**FINAL SAFETY EVALUATION BY THE OFFICE
OF NUCLEAR REACTOR REGULATION**

**TRICONEX TOPICAL REPORT 7286-545-1,
REVISION 4**

INVENSYS OPERATIONS MANAGEMENT

PROJECT NO. 709

Figure 3.3.5-1 – OBE Test Acceleration

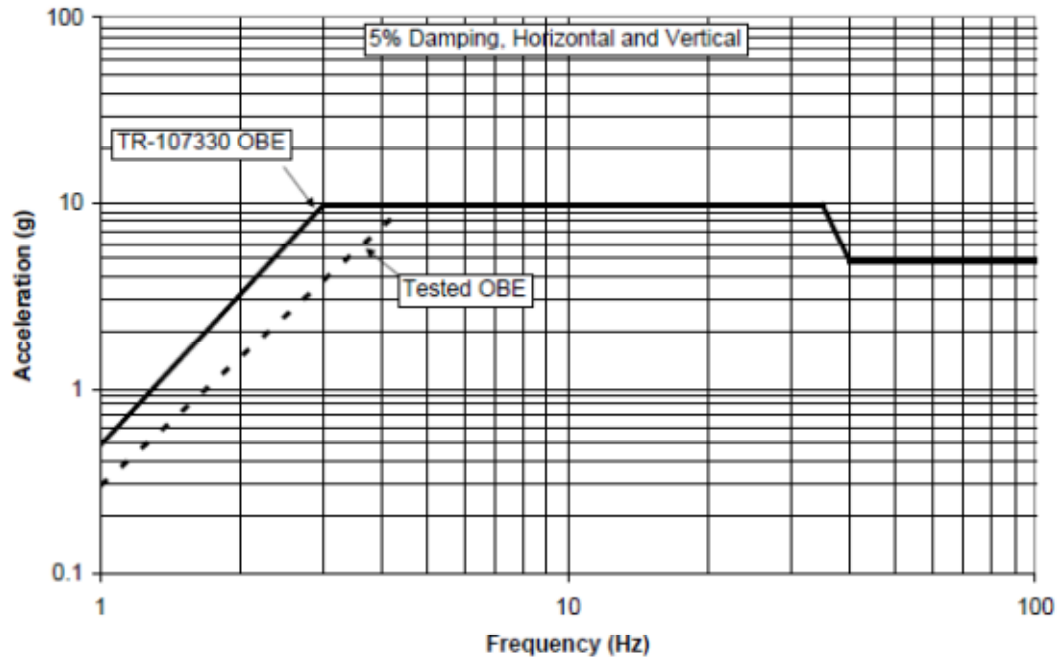
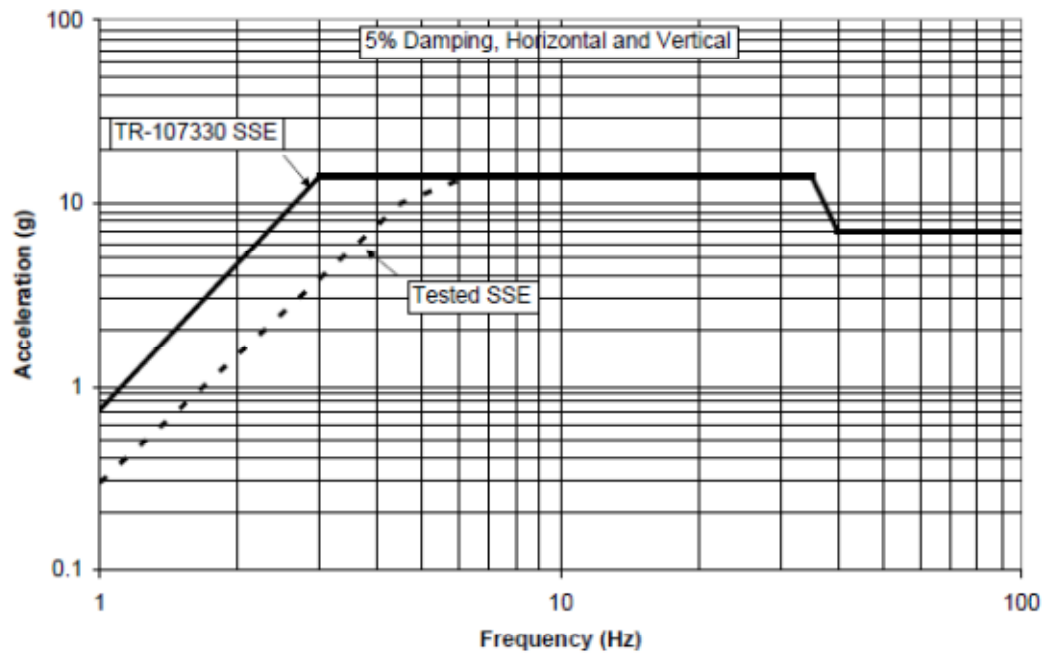
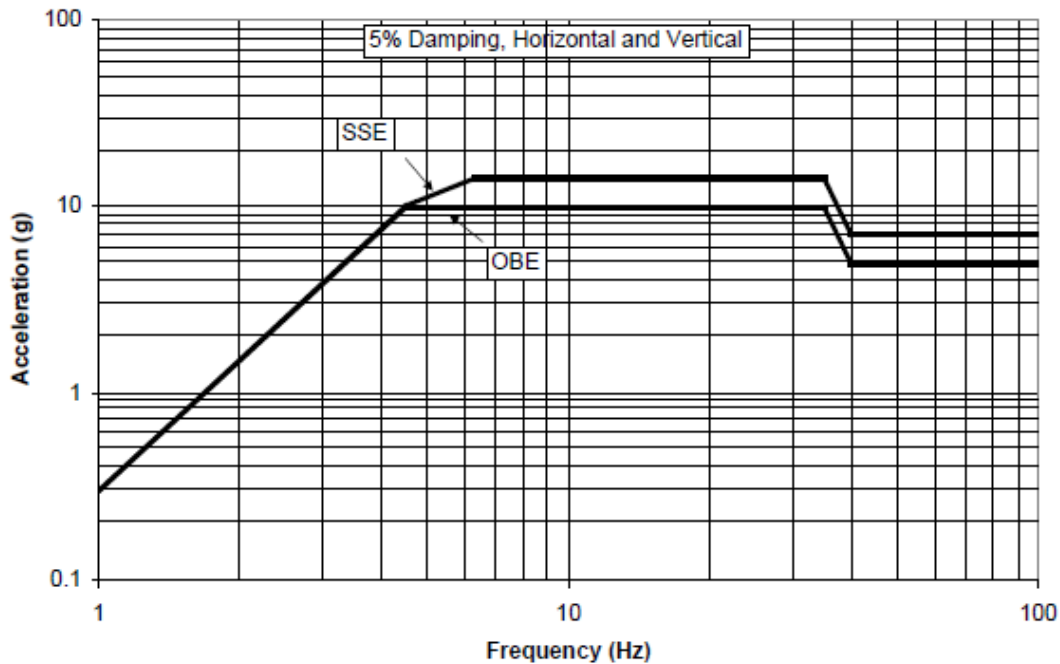
The NRC staff determined that the tested Tricon V10 system equipment is qualified to the tested triaxial seismic simulator table limits shown in Figures 3.3.5-1 through 3.3.5-3 below, with the exception of the low frequency region (below 6 Hz). For this reason the NRC staff finds that the Tricon V10 system did not fully meet the requirements of EPRI TR-107330 for seismic requirements, and before using Tricon V10 system equipment in SR systems in a NPP, licensees must determine that the plant-specific seismic requirements are enveloped by the capabilities of the Tricon V10 system. This determination and the suitability of the Tricon V10 system for a particular plant and application is the responsibility of the licensee.

Figure 3.7.2.1-1 – Safety to Non-Safety w/ MVDU via One Way Link

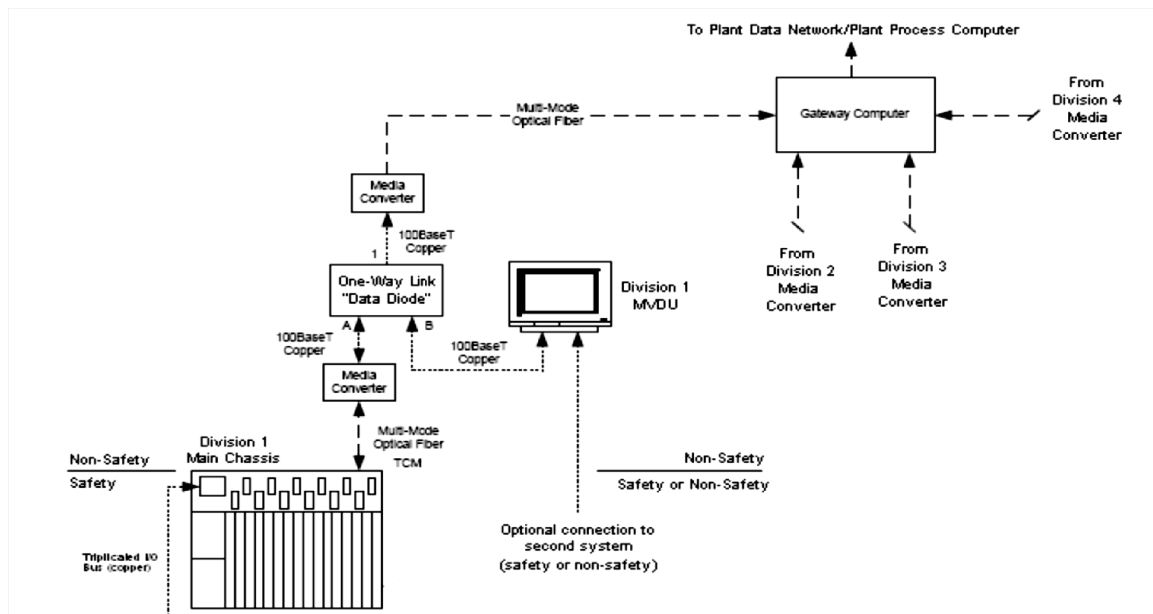
The NRC staff has determined that the data isolation function provided by the Port Tap device provides reasonable assurance that a fault or failure within the external computer system will not adversely affect the ability of a Tricon Safety System to accomplish its safety functions provided that the following ASAI's are performed.

1. Verify that the Port Tap device model number is either PA-CU, or PAD-CU. Use of any other device to accomplish this function will require additional analysis. Since the original review of part No. PAD-CU Port Tap required NRC staff examination of actual schematic drawings of the circuitry to determine that there was no inbound communications path associated with Port C, a similar schematic review for any replacement or updated model of the Port Tap must be performed to determine if the manner in which it is being used and configured are acceptable.
2. Ensure that the Port Tap device is configured in the manner illustrated in Figure 3.7.2.1-1 below.

The NRC staff determined that NSR equipment (e.g., plant computer) may be connected to the TCM through a port tap device as described above. This approval is subject to application specific review items noted above to verify the port tap device meets the precedent criteria (i.e., verify model number) and to verify port tap configuration in the system. An MVDU may be connected through the port tap as shown in Figure 3.7.2.1-1. However, approval of the MVDU will require review of plant specific procedures and review of the plant specific configuration.
